Îles-de-la-Madeleine Airport

Terminal building upgrade – Lot1

ADDENDUM N°02

Issued for Addendum n°02
2016-07-06

PLAN D'AMÉNAGEMENT TEMPORAIRE/ TEMPORARY LAYOUT PLAN

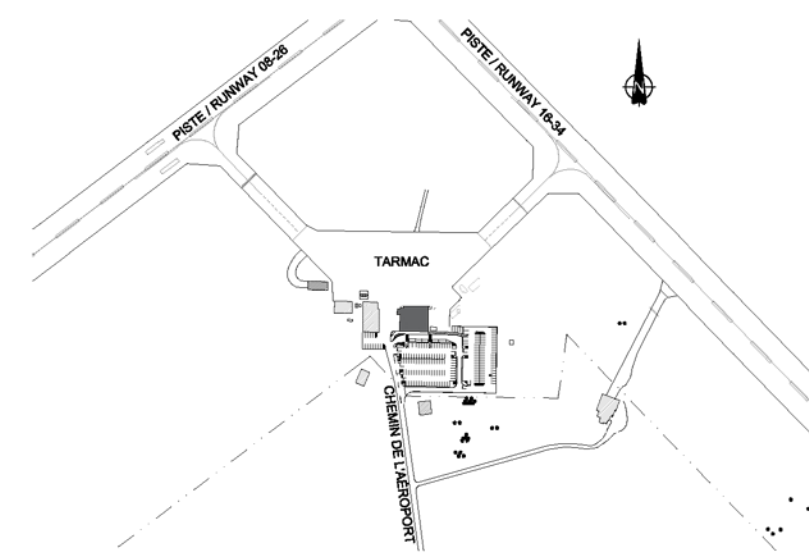
2. A037 – Temporary layout plan

- 1.Add the following door numbers: 002T; 006T; 013T see plan for location and coordinate with hardware indicated in the doors hardware section included.
- 2.Modify note 11 as indicated in the included revised plan

- 11
- PORTE TEMPORAIRE AVEC CLOISON TEMPORAIRE DE CHANTIER.
HAUTEUR : JUSQU'AU PONTAGE D'ACIER.
BO.C.1 PANNEAU DE CONTREPLAQUE, BON UN CÔTÉ, 16mm
COL.AC.1/GY COLOMBAGE D'ACIER, GALVANISÉ 92mm x
(CAL. 18 = 1.087mm) @ 300mm c/c.
ISOL.12/AC ISOLANT DE FIBRE MINÉRALE EN NATTES
ACOUSTIQUES.
COUPE-VAPEUR EN POLYÉTHYLÈNE DU CÔTÉ INTÉRIEUR
GY.P.3 PANNEAU DE GYPSÈ PARE-VAPEUR, RÉSISTANT À
L'HUMIDITÉ ET À LA MOISSISURE, 16mm.
FOURNIR 6 FÊMETRES DE 1220mm x 650mm @ 1800mm
DU PLANCHER, AVEC CADRE EN ACIER, SCELLER AU
POURTOUR DU CADRE ET VITRAGE DE TYPE BROCHE
"GEORGIAN".

- DEMOLISH EXISTING WALL FROM SLAB TO WINDOW SILL, REMOVE
WINDOW, FOR TEMPORARY ENTRANCE. PROVIDE A TEMPORARY METAL
SILL. PROVIDE AN ENCLOSURE AROUND THE OPENING TO RECEIVE THE
TEMPORARY DOOR FRAME.
